UNITED STATES PATENT AND TRADEMARK OFFICE

APPLICATION NO.	FILING DATE	FIRST NAMED INVENTOR	ATTORNEY DOCKET NO.	CONFIRMATION NO.
09/980,295	11/29/2001	Nils Alveby	32207	1433

Office Action Summary

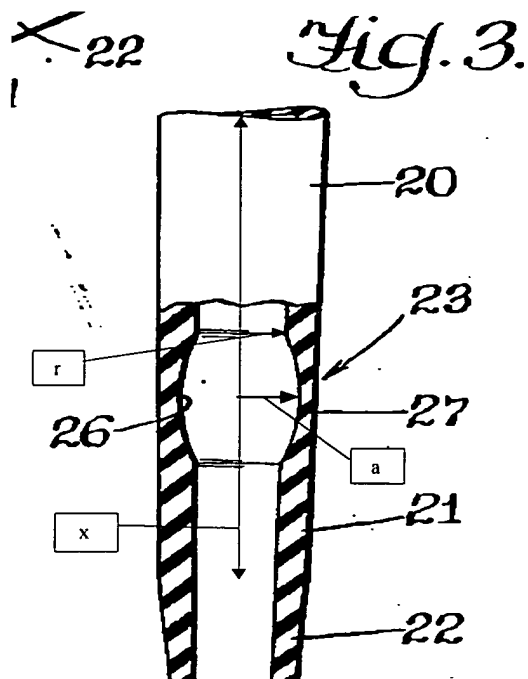
In regards to claim 5, Larson '201 in view of Larson '243 discloses the claimed invention except for the cross-sectional shape of the channel forming a first outward portion including a radius (r) and a second outwardly extending portion. In figure 3 below, Hein teaches the cross-sectional shape of the channel forming a first outward portion including a radius (r) and a second outwardly extending portion "to provide an improved milker" (col. 1, line 78). It would have been obvious to one having ordinary skill in the art at the time the invention was made to fabricate the cross-sectional shape of the channel with a first outward portion including a radius (r) and a second outwardly extending portion to provide an improved milker, as taught by Hein.

In regards to claim 8, in figure 3 above, Hein discloses the channel having a longitudinal center axis (x), wherein a distance (a) between the second portion and the center axis (x) is larger than the radius (r) seen in a cross-section through the transition portion.
